In compliance with the provisions of Section 179 of the Planning and Development Act 2000 (as amended) and Part 8 of the Planning and Development Regulations 2001 (as amended) and in compliance with the provisions of the Local Government Act 2001 and pursuant to the requirements of the above, notice is hereby given of Dublin City Council's intention to carry out the following works:

**Proposed Public Realm Improvement Works to Cathedral Street and Sackville Place
Dublin 1.
Plan Ref No. 4552/17**

Cathedral Street Proposed Plan

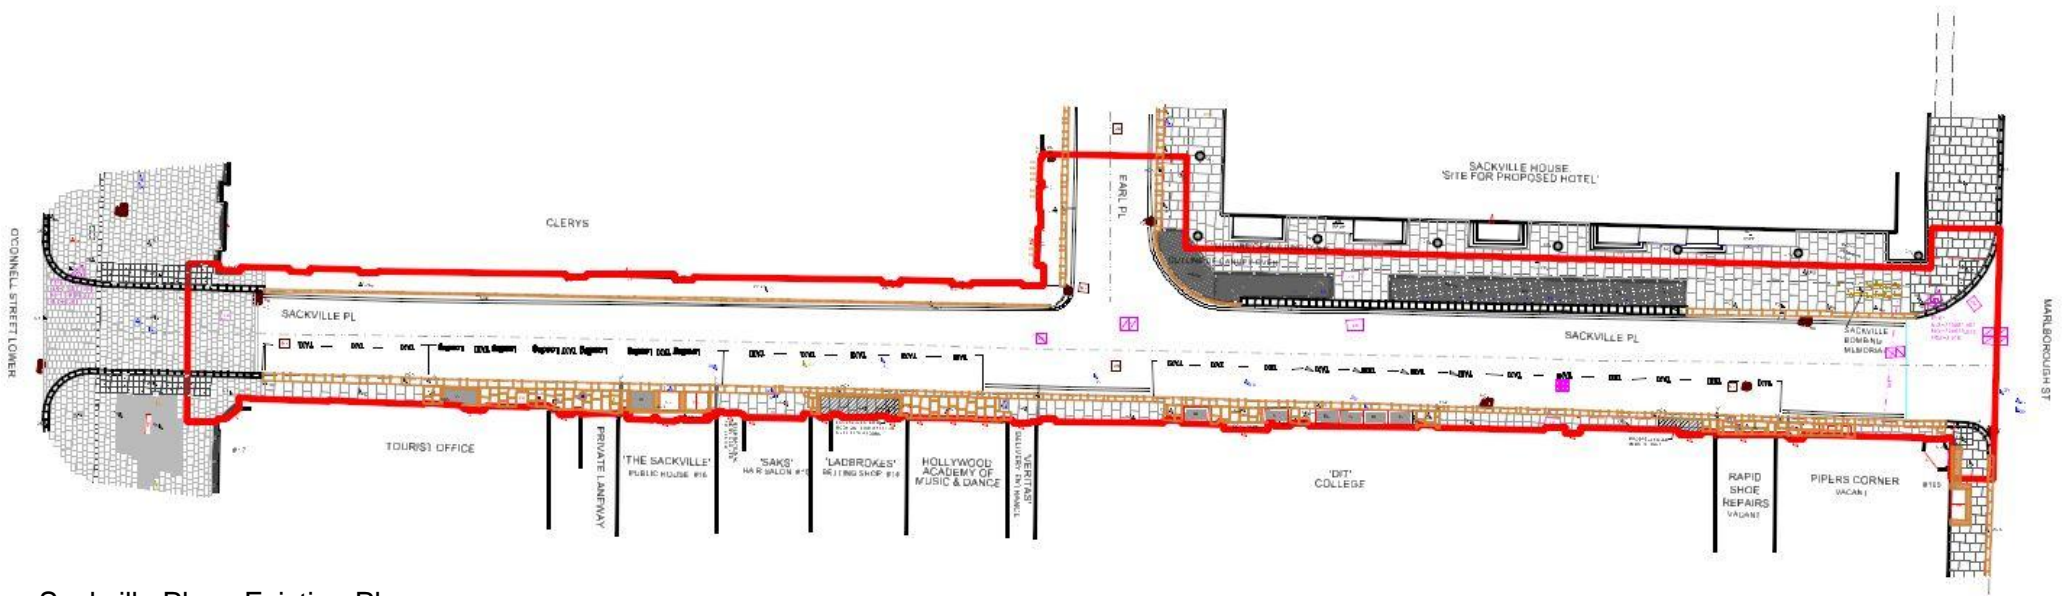
The wider area of Cathedral Street (between Thomas Lane and O'Connell Street) currently has loading areas and two disabled parking spaces on the north side and taxi parking on the south side. This area has a poor quality concrete surface although the area in the vicinity of the junction with O'Connell Street has been upgraded. The narrower area west of Thomas Lane has a paved surface, with pedestrian and vehicular areas delineated by drainage channels and bollards. In the wider area it is proposed to provide taxi parking on the north side and disabled parking and loading on the south side. The street would narrow in the area adjacent to the junction to O'Connell Street, allowing for one-way traffic (west-east only) with a tree and a bench on each side of the pinch point. Retained antique kerbs would be re-laid between the parking areas and the footpaths. A second pinch point defined by trees and seating would be provided just west of the junction with Thomas Lane. The street would be repaved in granite paving. The narrower area between Thomas Lane and Marlborough Street would also be repaved in granite paving and the footpath would be widened. The area between the footpath and the road would be delineated by bollard strips and sockets. A number of benches are shown along the bollard strip to the south.
